Proposal for Supplement 4 to the 06 series of amendments to UN Regulation No. 16

This text below was produced by the experts of the supply industry to propose an amendment to regulation ECE-R 16 with focus on the uniform provisions on safety belts. The modification is marked with bold letters.

Diagram 1 - Upper Shoulder Belt Force versus Time with Strap Sensitivities (WS 1.0 g up to 3.0 g)

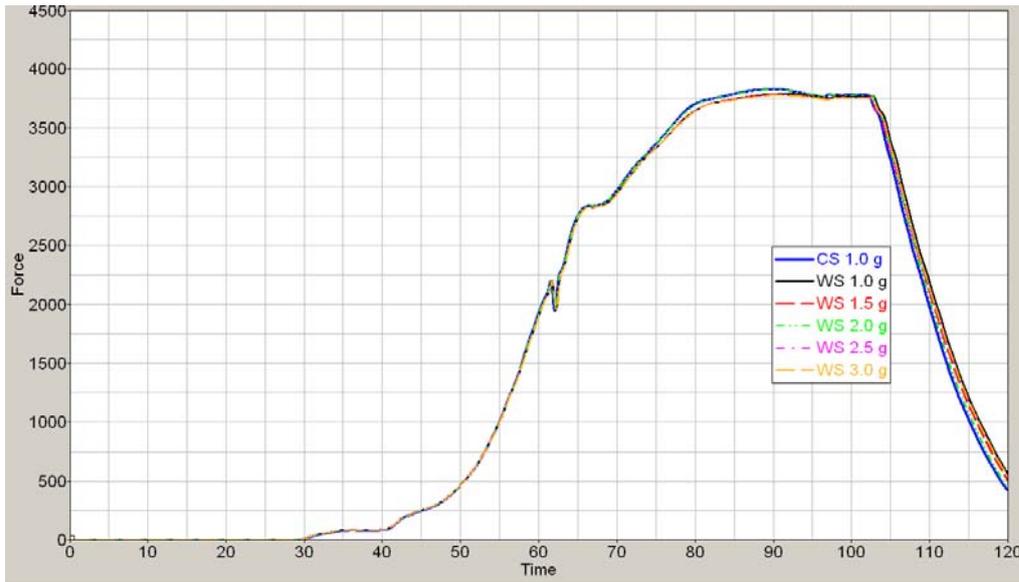
Vehicle sensitivity or strap sensitivity are switched off each to understand its solely influence to the belt forces. The seen onset of shoulder belt force shows no difference due to differently chosen levels of strap sensitivities (WS). The diagram incorporates

additionally for reference purpose the upper shoulder belt force with a vehicle sensitivity of 1.0 g (CS).

Diagram 2 – Belt movement measure above the Retractor

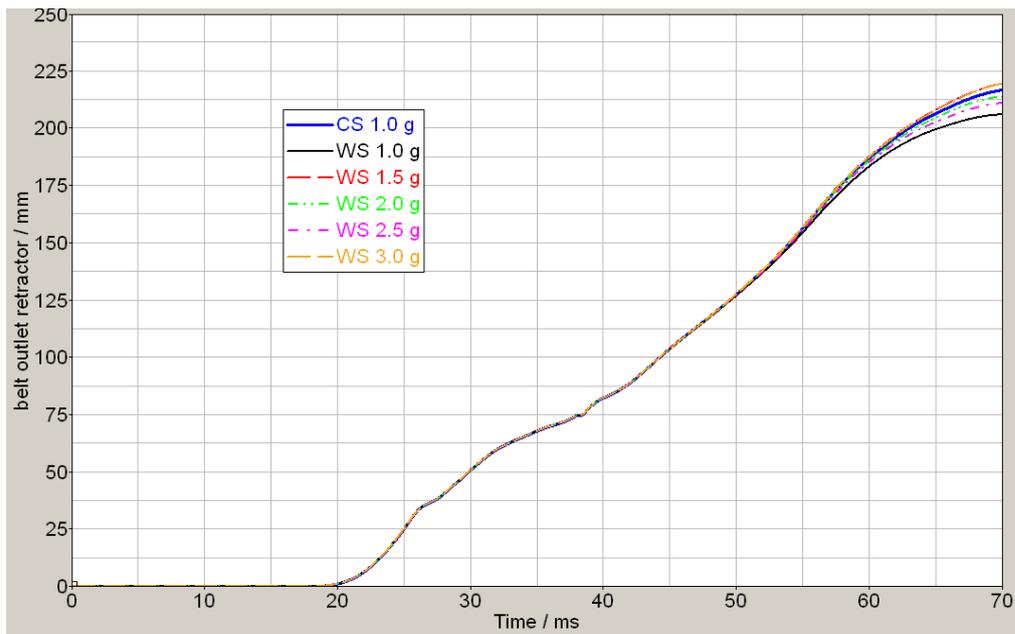
The consequently appearing belt movement analyzed above the retractor housing, which represents the belt spending for the occupant kinematics and finally maximum forward displacement is shown in the diagram 2. The variation visible after 55 ms is affected by the restraint system (air bag deployment, air bag to I/P contact, etc.). It can be demonstrated that different sensor layouts, in this case up to a webbing sensitivity of 3.0g do not show any evidence for a change in the occupant kinematics.

Diagram 3 – Shoulder Belt Force versus Time with Strap Sensitivity 2.0g and 3.5g

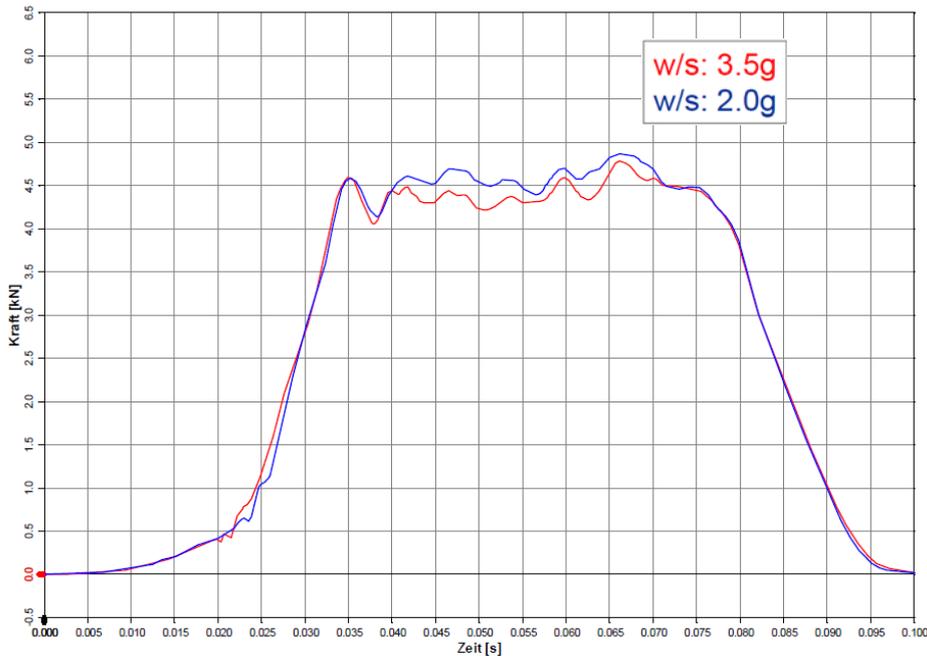
- Investigation with ECE-R 16 sled tests with variation of strap sensitivity
 Another study performed on a ECE-R16 sled was set up to demonstrate potential differences between sensor layout 2.0g and 3.5g. To eliminate any kind of influence coming from the vehicle sensitivity, these elements were detached from the retractor. Diagram 3 shows the shoulder belt forces versus time, specifically with a webbing sensitivity of 2.0g and 3.5g. There is no relevant difference visible.

Diagram 4 – Forward Displacement TNO-10 on ECE-R 16 sled with Strap Sensitivity 2.0g and 3.5g

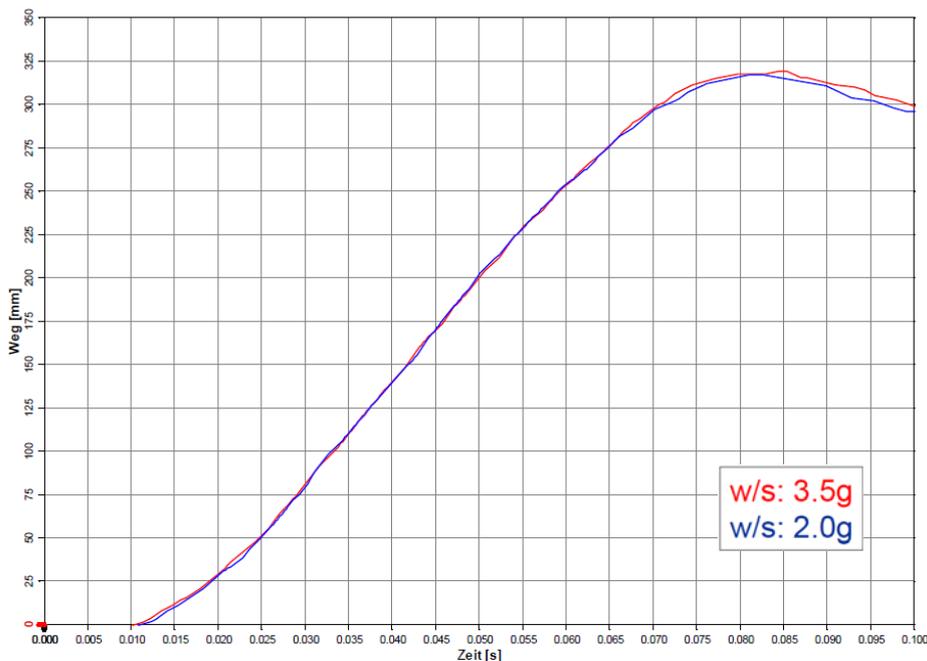
The same counts for the forward displacements of the TNO-10 dummies, which are shown in Diagram 4. The kinematics with both sensitivities can be described as equal.
